RE: Well Decommission at 1801 Park Street, Alameda, CA

Re: **Former Chevron Service Station #9-4463**
1801 Park Street, Alameda, California

RE: Former Chevron SS# 9-4463, 1801 Park St, Alameda

FORMER CHEVRON SS # 9-4463

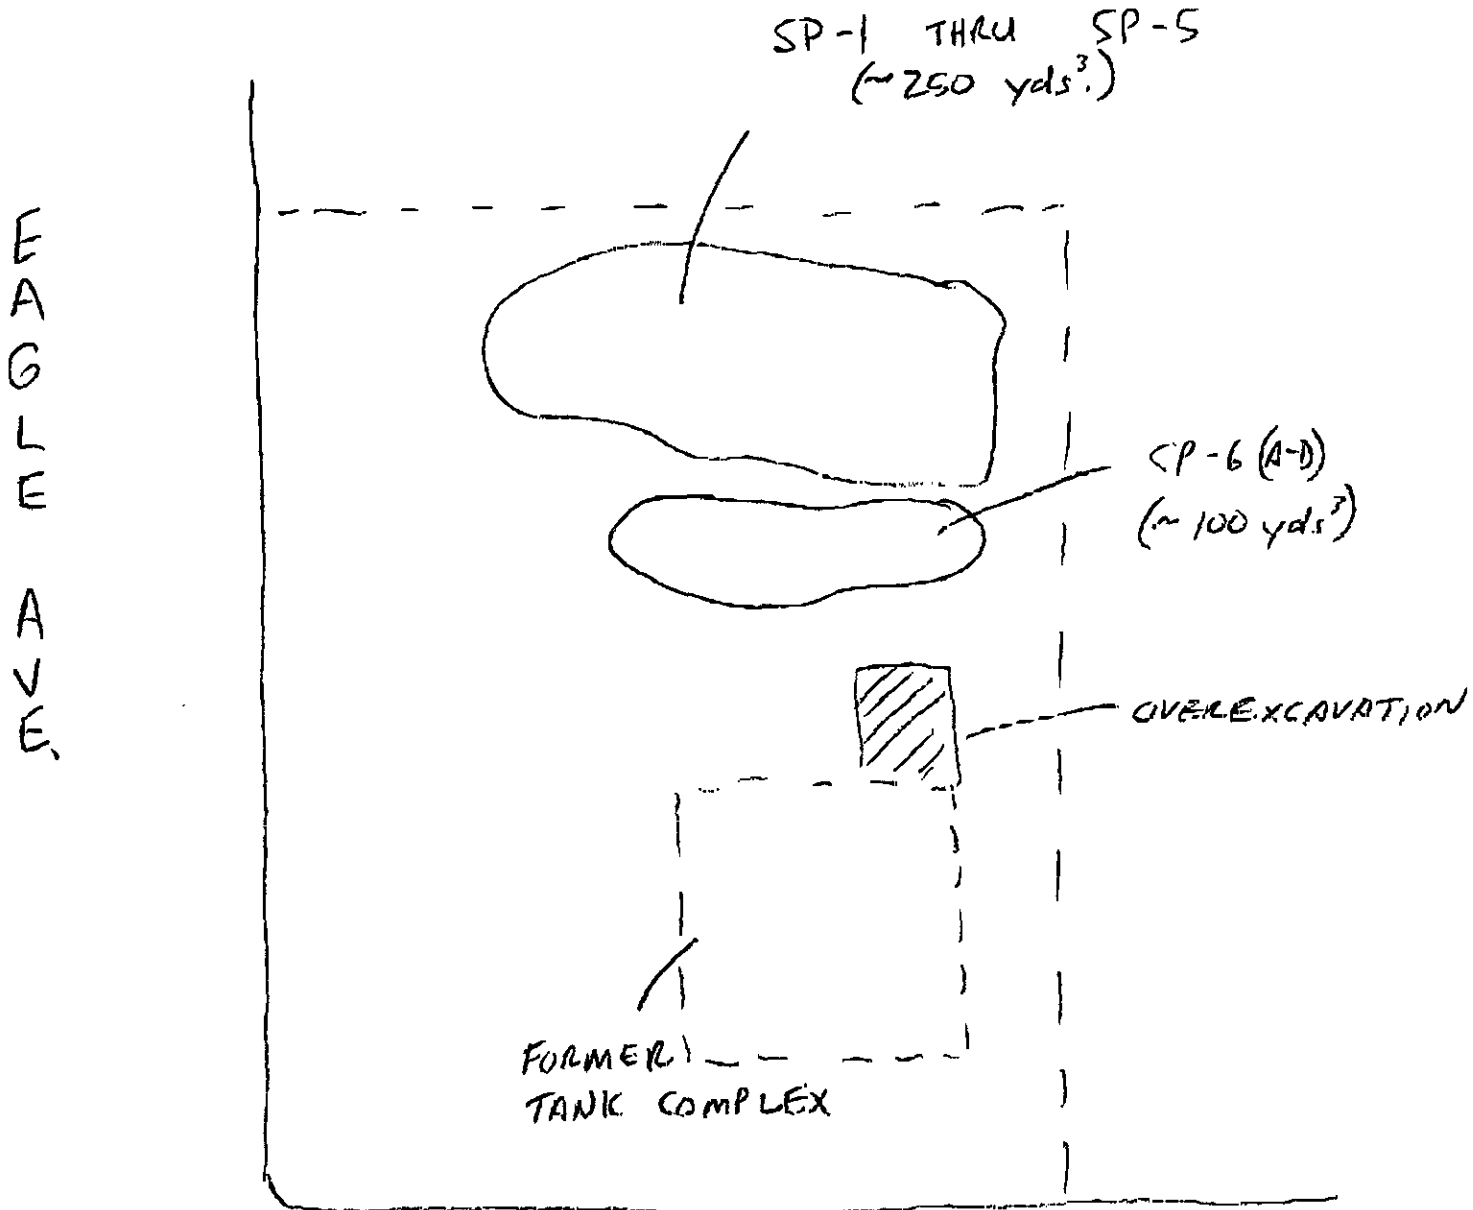
Results of soil stockpile sampling for reuse at Chevron SS# 9-4463, 1801 Park Street, San Francisco, CA. Are stockpiles SP-2 through SP-4 acceptable for reuse onsite? If not, please advise on acceptable BTEX levels for reuse of soil onsite. Please call at (510) 339-3222 if you have questions or comments.

OK to use SP1-SP4
to backfill.
Need to sample / remediate
SP-6

CHEVRON SS# 9-4462
 1801 PARK ST.
 ALAMEDA, CA.

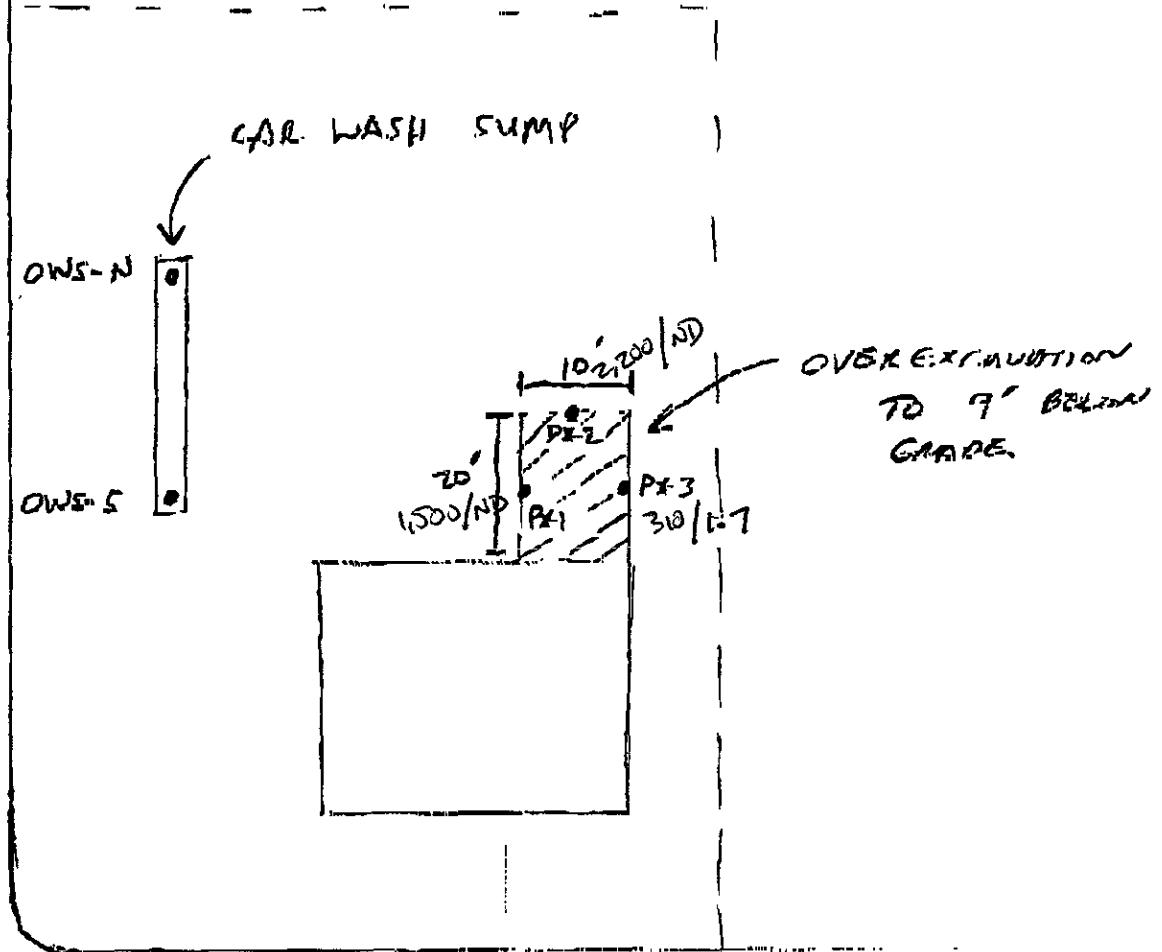
① 15 there was north of former tank pit.

② send site plan of location of mws in relation to pit + pump island.
